PRODUCT ADVISORY

**Data Sheet Specification Change for
Intersil Products ISL59601*,
ISL59602*, ISL59603*, ISL59604*,
and ISL59605***

**Refer to:
PA12072**

Date: September 6, 2012

- Figure 45 - Application Circuit for UTP Cable (Page 20):

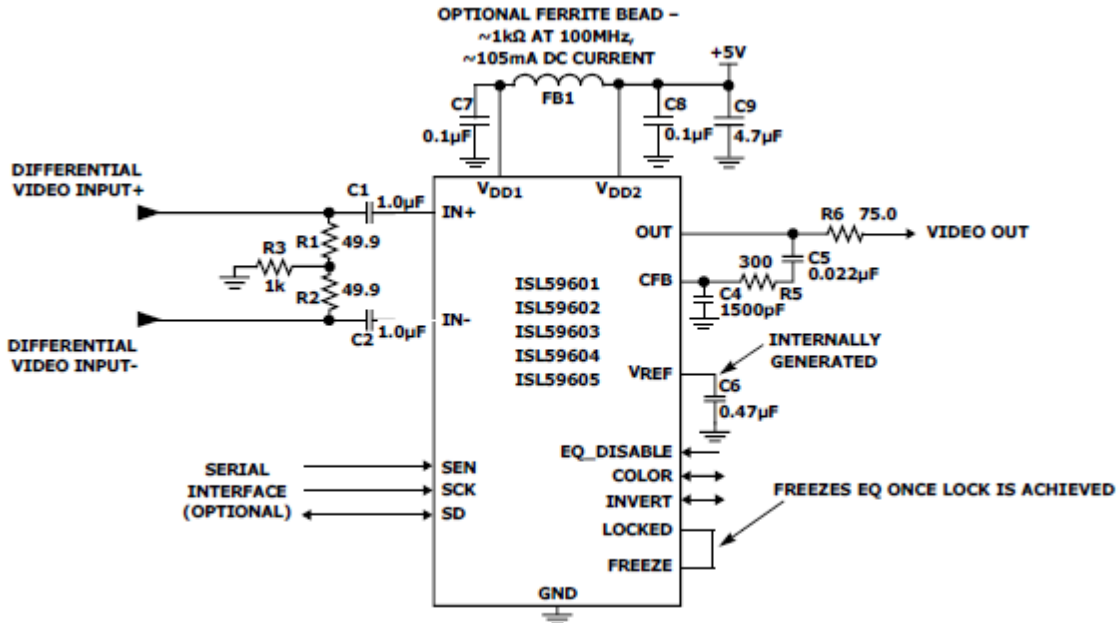
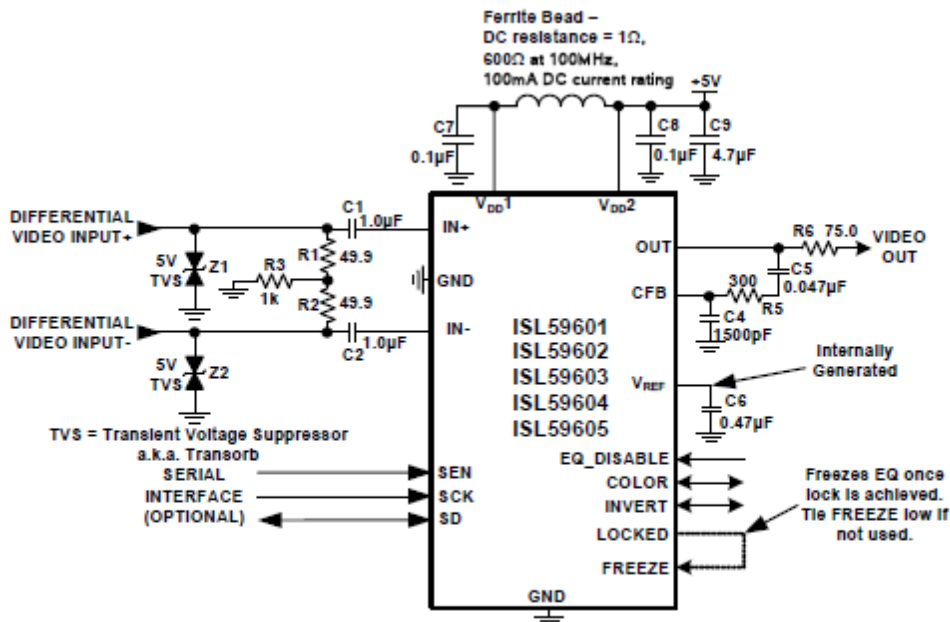
This advisory is to inform you that Intersil has made an enhancement to the data sheet application circuits for the listed ISL59601*, ISL59602*, ISL59603*, ISL59604*, and ISL59605* products. Although the current application circuitry is functionally correct, the update will improve Intersil's product performance. The changes affect the termination requirements outlined in the *Figure 45 – Application Circuit for UTP Cable*, *Figure 46 – Application Circuit for COAX Cable*, *Figure 47 – Application Circuit for UTP/COAX Cable*, and verbiage in the related sections. Details regarding the changes to the figures are contained on the following pages. The updated data sheet is available on the Intersil web site at <http://www.intersil.com/content/dam/Intersil/documents/fn67/fn6739.pdf>.
